STAFF REPORT: 7/13/2022 REGULAR MEETING

APPLICATION NUMBER: #22-7908

ADDRESS: 1620 ATKINSON

SCOPE: DEMOLISH GARAGE, FENCE, REAR BALCONY AND DECK, (WORK COMPLETED WITHOUT APPROVAL), ERECT NEW GARAGE

Proposed Garage Elevations 1-3, by Applicant

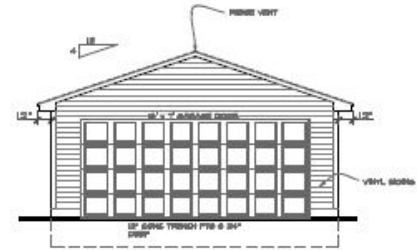
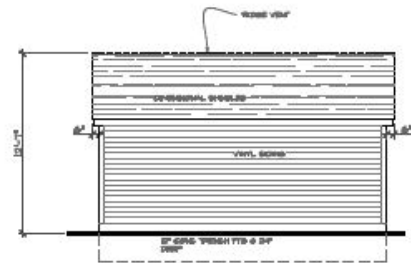
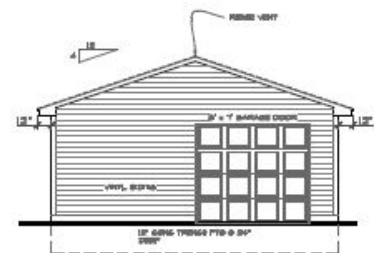
- The proposed garage, with the low-pitched, front-gabled roof and panel doors are an appropriate design that does not conflict with the design of the house and is appropriate for the district.

- It is staff's opinion that the proposed vinyl siding is not an appropriate material consistent with the design and material of the house, as shown in the drawings. After discussion with the applicant, staff received updated material from the applicant to revise the proposed drawings so that Hardie siding replaces vinyl for this proposal. It is staff's opinion that the smooth surface version of this Hardie board, would be a more appropriate material, rather than the wood grain version that is now in this proposal.

- Staff received various dimensions for siding material for the garage. Because the rear of the house has 4" lapboard smooth siding, it is staff's opinion that this dimension and design would be an appropriate match for the garage siding.

- Staff observed that the garage has no gutters or downspouts provided in the drawings.

- The Hardie board siding of the garage be of similar dimension, color and smooth surface to match the rear siding of the house.
- Downspouts and gutters added to the garage.
- Garage door and exterior light fixture details provided for review and approval.
- Privacy fence stain or paint provided for review and approval.
- Deck skirting of a design more appropriate to the architecture of the house.
- Staff receive a final plan showing product and detail description of the above work.
- The applicant provides HDC staff a review of the above items before installation.

Site Plan 1 by Applicant, showing location of proposed garage.

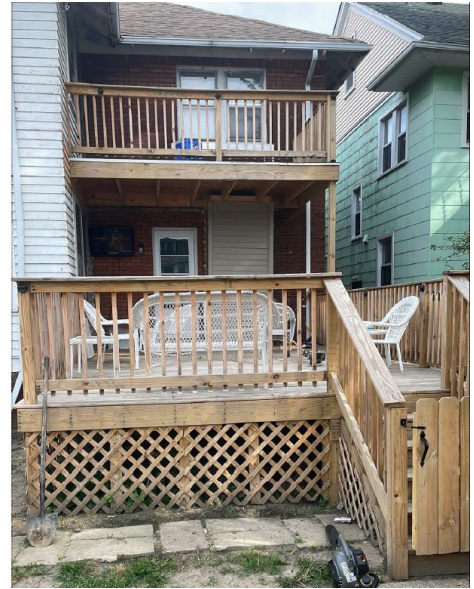
- The proposed site for the garage moves from the historic footprint, from the northwest corner to the northeast corner of the lot. It is staff's opinion that this shift is not significant nor impactful to the historic setting of this property.
